Proposal for the 09 series of amendments to UN Regulation No. 16 (Safety-belts)

Submitted by the expert from France

The text reproduced below was prepared by the expert from France to clarify the requirements for safety-belt reminder systems on test procedure (first and second level warning), visual warning and requirements for Seat belt Reminder of rear seat row(s). The modifications to the current text of the UN Regulation are marked in bold for new or strikethrough for deleted characters.

Model A

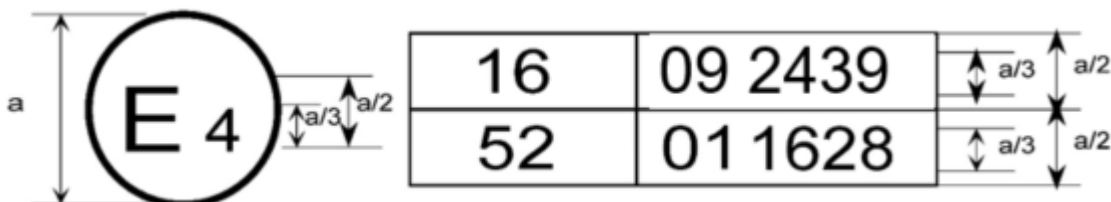
The above approval mark affixed to a vehicle shows that the vehicle type concerned has, with regard to safety-belts, been approved in the Netherlands (E 4) pursuant to Regulation No. 16. The approval number indicates that the approval was granted according to the requirements of Regulation No. 16 as amended by the 09 series of amendments.

Model B

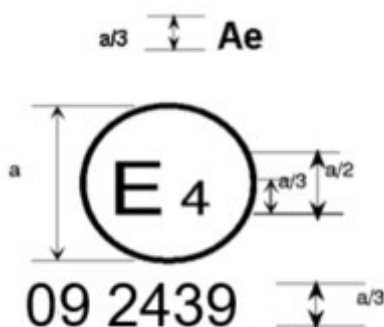
The above approval mark affixed to a vehicle shows that the vehicle type concerned has been approved in the Netherlands (E 4) pursuant to Regulations Nos. 16 and 52. 1/ The approval numbers indicate that, at the dates when the respective approvals were given, Regulation No. 16 included the **09** series of amendments and Regulation No. 52 the 01 series of amendments.

2. Arrangements of the safety-belt approval marks (See paragraph 5.3.5 of this Regulation)

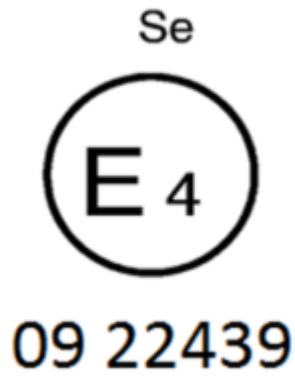
The belt bearing the above approval mark is a three-point belt ("A"), fitted with an energy absorber ("e") and approved in the Netherlands (E 4) under the number 082439, this Regulation already incorporating the 06, 07, **08 or 09** series of amendments at the time of approval.

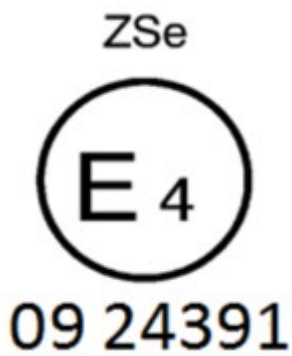
The belt bearing the above approval mark is a special type belt ("S"), fitted with an energy absorber ("e") and approved in the Netherlands (E 4) under the number 0822439, this Regulation already incorporating the 06, 07, **08 or 09** series of amendments at the time of approval.

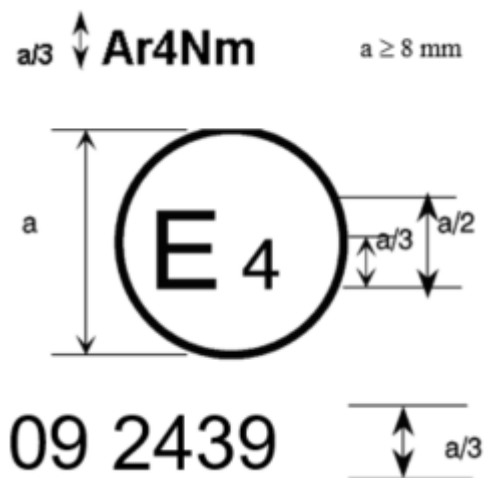
The belt bearing the above approval mark is part of a restraint system ("Z"), it is a special type belt ("S") fitted with an energy absorber ("e"). It has been approved in the Netherlands (E 4) under the number 0824391, this Regulation already incorporating the 06, 07, **08 or 09** series of amendments at the time of approval.
